**STAFF REPORT  
HISTORIC AND CULTURAL LANDMARKS COMMISSION  
CITY OF FORT WORTH, TEXAS**

DATE: December 12, 2016

<b>REQUEST</b>	Certificate of Appropriateness
<b>APPLICANT/AGENT</b>	William Ryan Perry
<b>LOCATION</b>	1932 6 <sup>th</sup> Avenue
<b>ZONING/ USE (S)</b>	B/HC
<b>NEIGHBORHOOD ASSOCIATION</b>	Fairmount Southside

The applicant requests a Certificate of Appropriateness to remove a rear deck and extensions and construct a second-story addition to the main house.

Figure 9. Proposed Upper Floor Plan

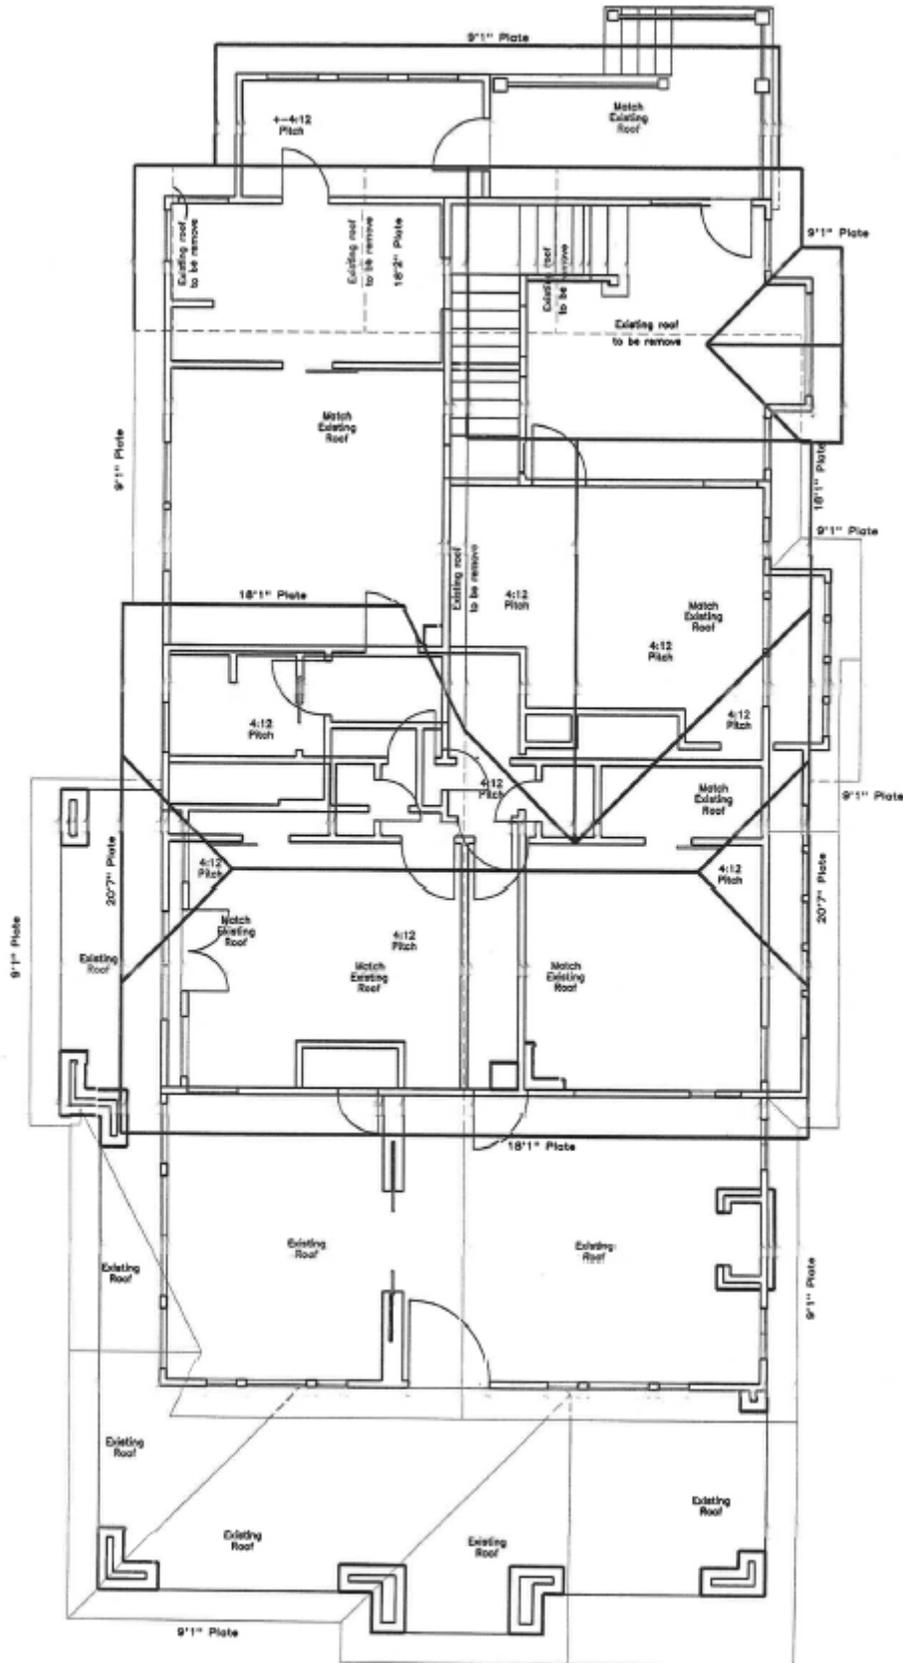
The proposal to remove a rear deck and extensions; construct a rear extension; enclose the rear porch; and construct a second-story addition is compatible with the scale and massing of the principal residence and it is consistent with the general scale and massing of adjacent structures. With the exception of several details, which are addressed in the conditions below, the new work will be sufficiently differentiated from the old.

- 1. That the windows in the new construction be 1/1 as appropriate;**
- 2. That historic details be omitted from the proposed new addition; and**
- 3. That the drawings be amended and resubmitted to the Planning and Development Department prior to the issuance of a Certificate of Appropriateness**

### LEFT ELEVATION

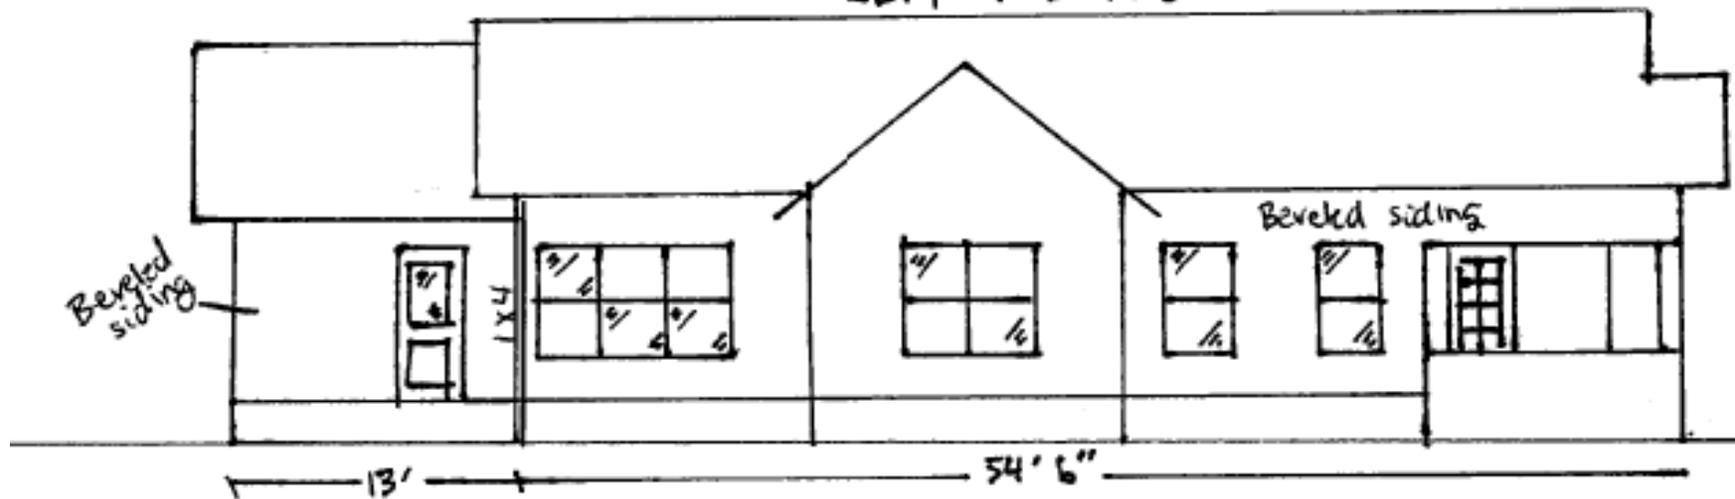
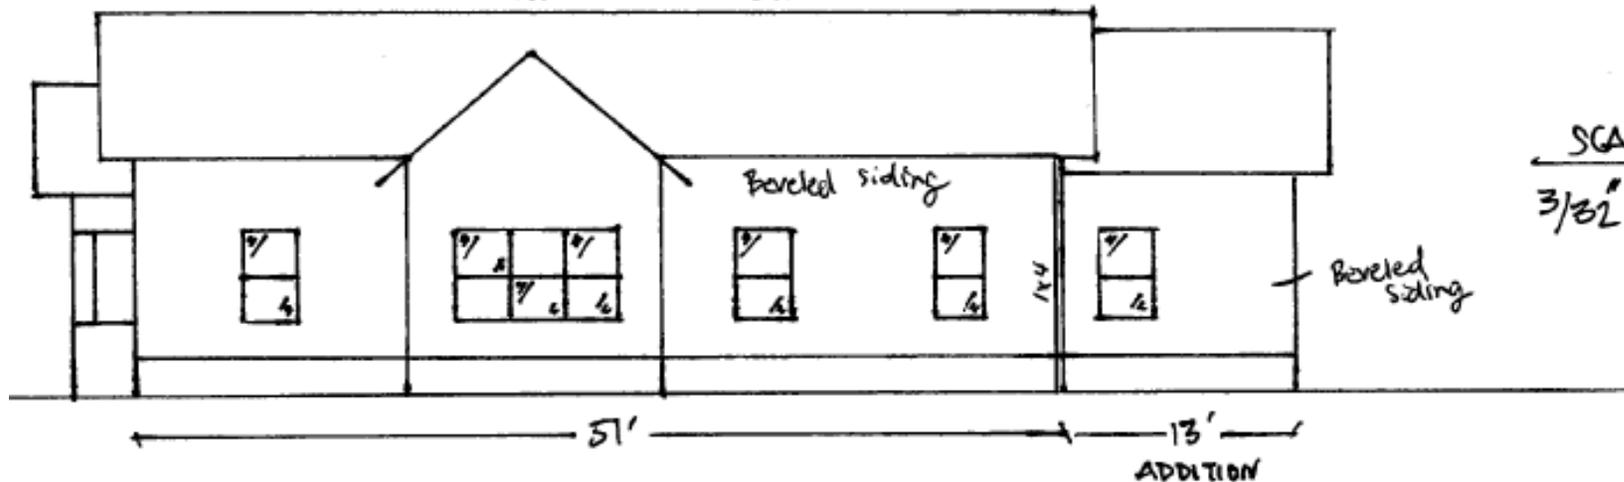
The proposal is to construct a single-story addition to the historic main house using materials that match the existing bungalow. The height and overall scale of the proposed addition is compatible with the character and appearance of the District and it tucks under the main gable, expressing a key preservation principle of establishing a subordinate relationship between the historic property and the addition. That the side wall that coincides with the historic wall plane hampers the subordinate relationship in plan, resulting in the concealment of a large portion of the historic corner of the house.

- a. **That the addition be sufficiently set-in to maintain the three-dimensional qualities of the historic corner;**
- b. **That the existing and proposed exterior materials be shown on the elevations; and**
- c. **That the drawings be revised to reflect the above conditions prior to the issuance of the COA.**
